RE: Congress Center - Morgan Stanley 22nd Floor Renovation – Permit Plan Architectural Sheet Revisions #1 Dated 09.13.12 **(Permit Application #12-165706-FA)**

SCOPE OF REVISIONS

1 / T-1 22ND FLOOR - DEMO PLAN

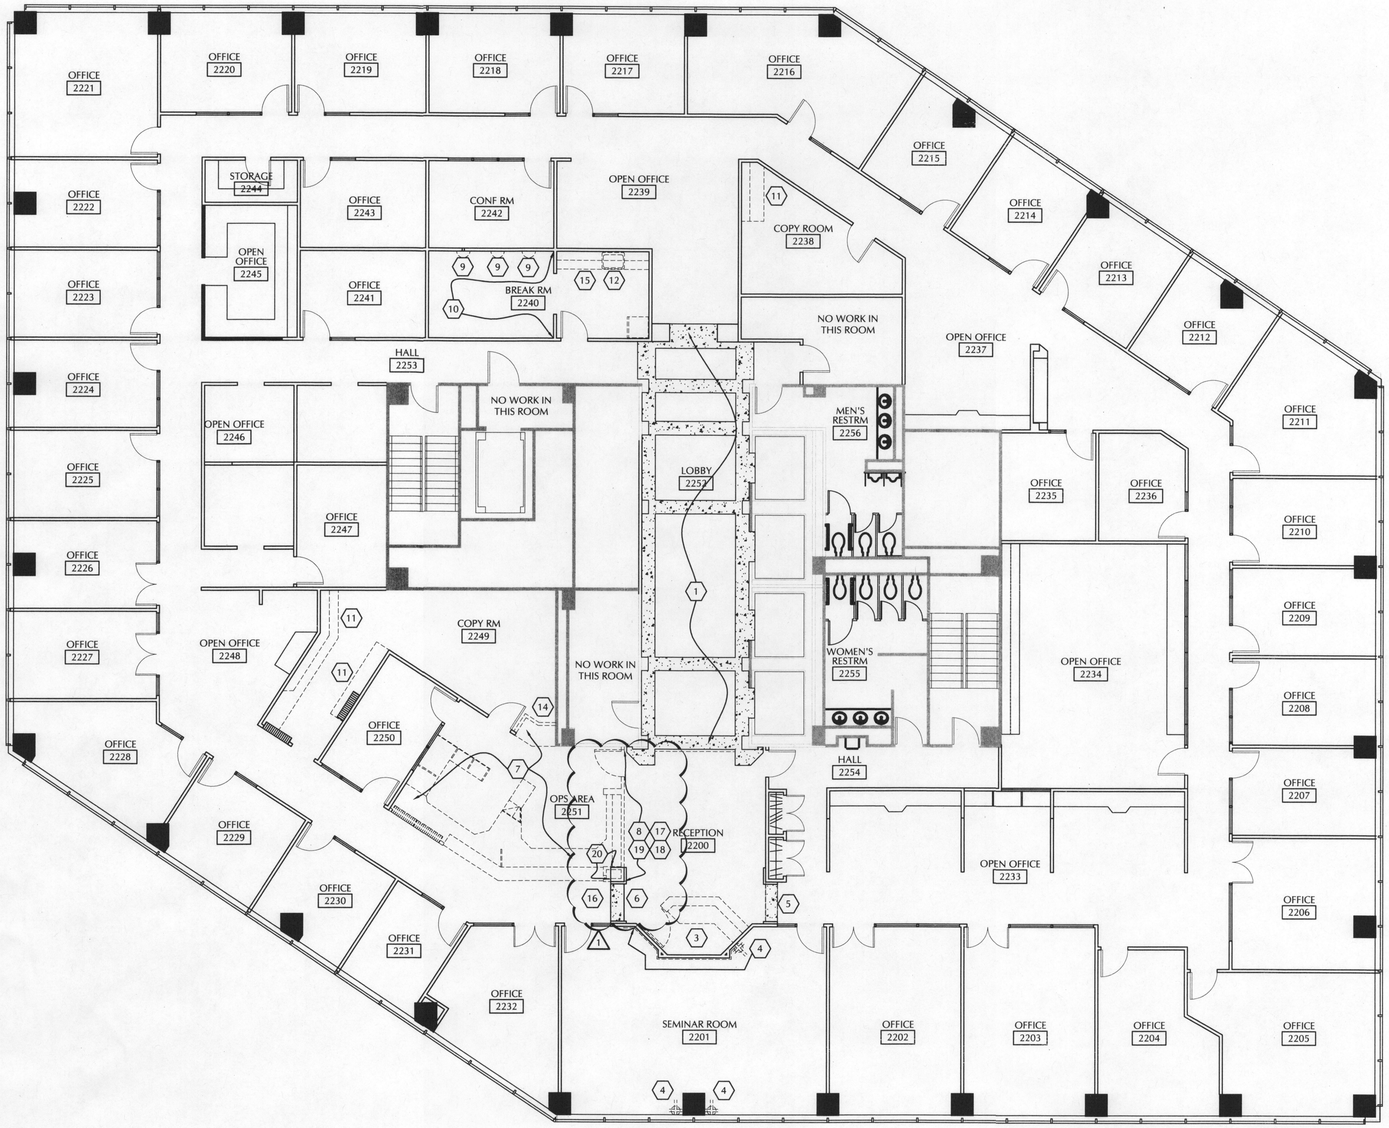
- Sheet T-1 (Demo Plan) – added keynotes
- Sheet T-2 (Floor Plan) – added keynotes
- Sheet T-3 (Finish Schedule/Details) – added detail of non-structural soffit
- Sheet T-4 (Elevations/Details) – revised elevations to show soffit location

17. EXISTING DOWNLIGHTS TO BE REMOVED.
18. LINEAR DIFFUSERS TO BE REMOVED AND RELOCATED AS REQUIRED TO ACCOMMODATE NEW SOFFIT.
19. DEMO GYP CEILING - EXTEND EXISTING ACOUSTICAL CEILING GRID AND TILE TO MATCH AS REQUIRED TO NEW SOFFIT LOCATION.

20. DEMO PORTION OF GYP TO ALIGN ARCHWAY - FINISH ARCHWAY IN WOOD TO MATCH EXISTING.

1 / T-2 22ND FLOOR - FLOOR PLAN

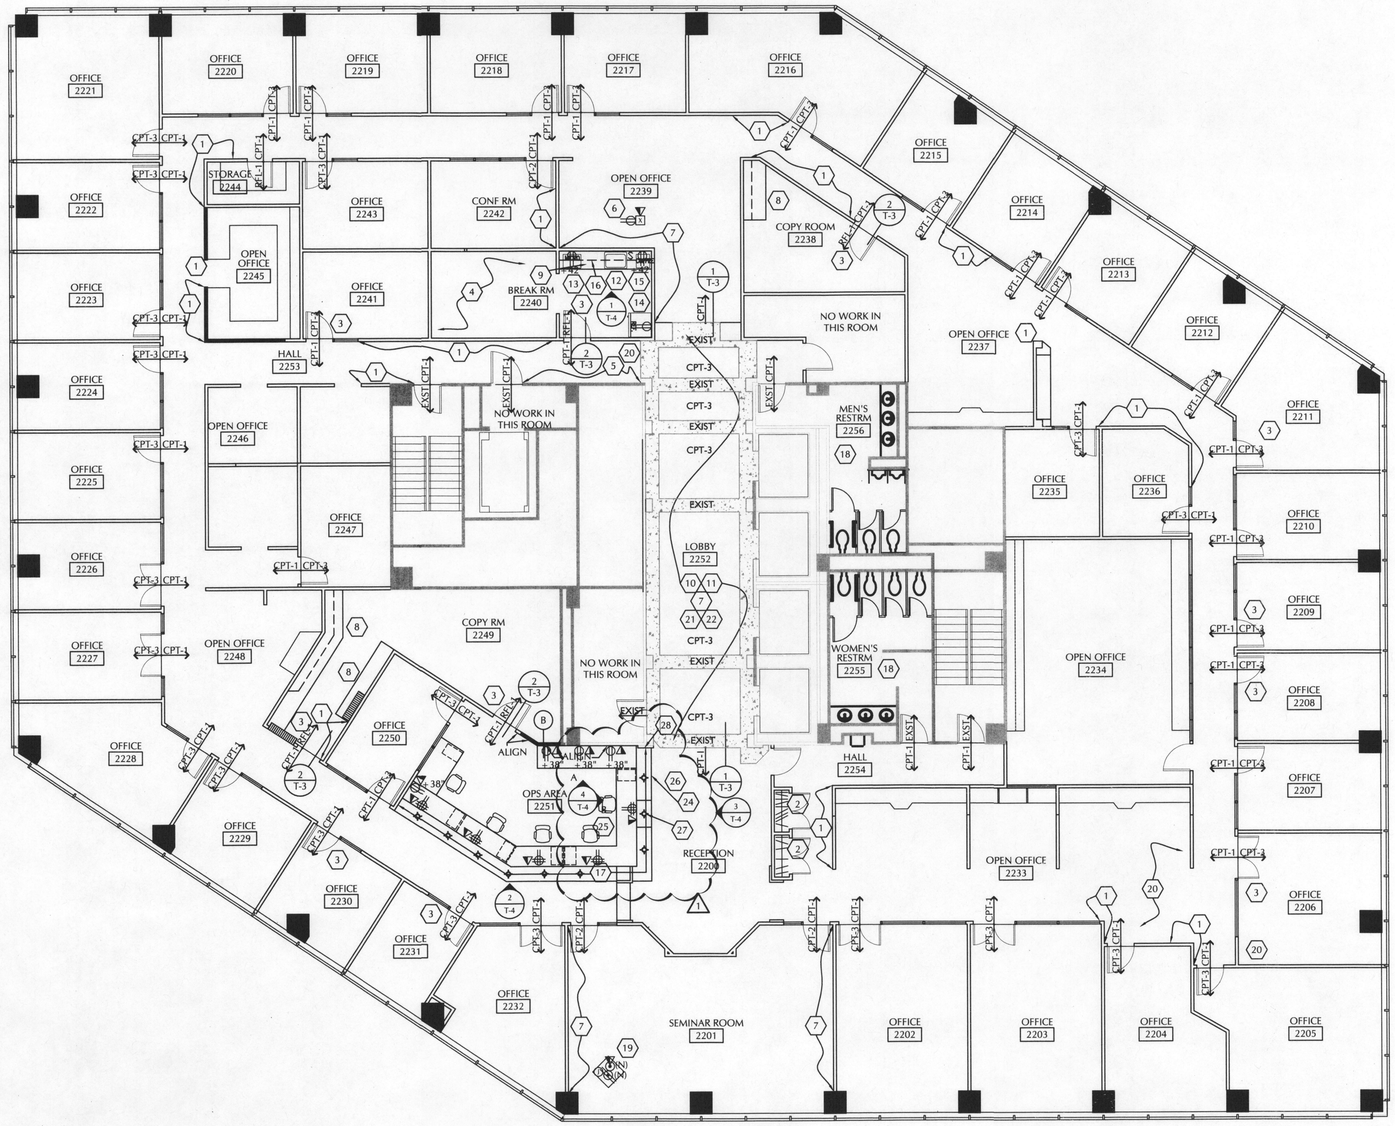
24. NEW GYP SOFFIT TO ALIGN ABOVE TRANSACTION TOP - REFER TO ELEVATIONS ON SHEET T-4, AND SOFFIT DETAIL 4/T-3. FINISH SOFFIT WITH WOOD TRIM FACING WAITING AREA. WOOD AND TRIM TO MATCH EXISTING. NEW WOOD SOFFIT TO ALIGN WITH EXISTING WOOD TRIM IN LOBBY AND WOOD ARCHWAY. PROVIDE NEW DOWNLIGHTS AT SOFFIT.
25. EXTEND EXISTING CEILING GRID AS REQUIRED TO ALIGN WITH NEW GYP SOFFIT - ADD (2) 2X2 RECESSED LIGHT FIXTURES TO MATCH EXISTING.
26. MODIFY CONCEALED HEAD SPRINKLERS AS REQUIRED TO ACCOMMODATE NEW SOFFIT.
27. CENTER DOWNLIGHT IN SOFFIT ABOVE ADA TRANSACTION TOP.
28. CENTER NEW PARTIAL HEIGHT WALL FOR OPS ON FAUX WOOD COLUMN.

4 T-3 NON- STRUCTURAL SOFFIT
1 1/2" = 1'-0"
GYP SOFFIT2

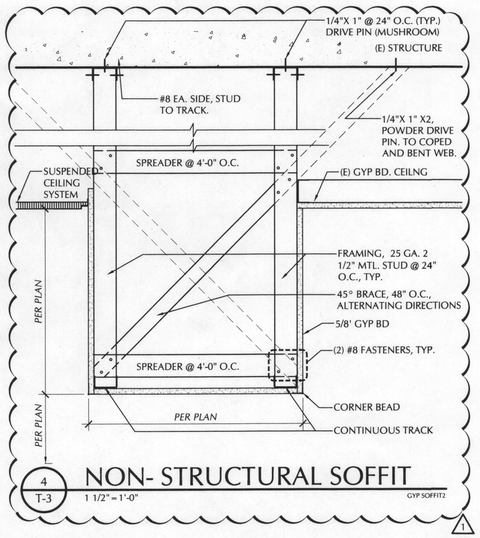
- Reconfigure Operations Area Desk 2251 to include non-structural soffit above transaction top at East side of casework, extend suspended ceiling grid and tiles at west side of desk up to new soffit, and cutting back gyp ceiling for new non-structural soffit on east side of desk as required.
